DESIGN PH	DRAWN BY PH	DART AEROSPACE LTD HAWKESBURY, ONTARIO, CANADA	
CHECKED 	APPROVED 	DRAWING NO. DSI 9253	REV. B SHEET 1 OF 1
DATE 05.10.14	TITLE 206 A/B FLOAT STEP MOD. KIT		SCALE NTS
A	03.02.26	NEW ISSUE	
B	05.10.14	REDESIGN

DART SERVICE INSTRUCTION

TO AMEND INSTALLATION DRAWING D206-628 REV. D/E

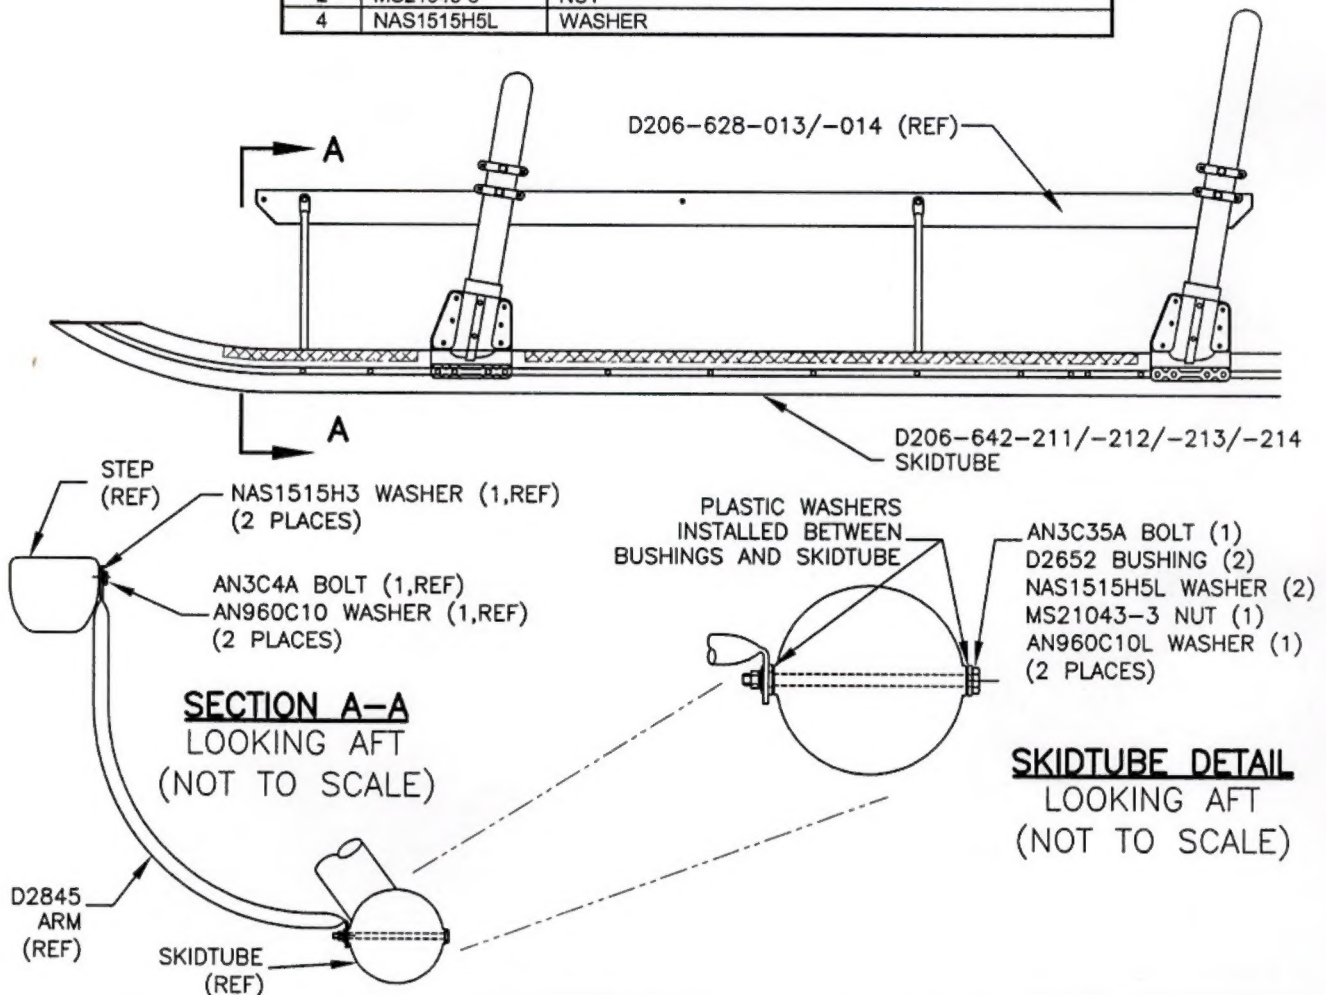
To make the D206-628-013/-014 Float Steps compatible with both the Dart D206-642-211/-212/-213/-214 Skidtubes and the Dart D206-590-011/-021 Kwik Float Emergency Floatation System. Install D2845 Arms between step and skidtube as shown

The following DSI9253-011 kit is available to make these changes possible:

-011	Part No.	Description
X	DSI9253-011	206 A/B FLOAT STEP MODIFICATION KIT
2	AN3C35A	BOLT
2	AN960C10L	WASHER
4	D2652	BUSHING
2	MS21043-3	NUT
4	NAS1515H5L	WASHER
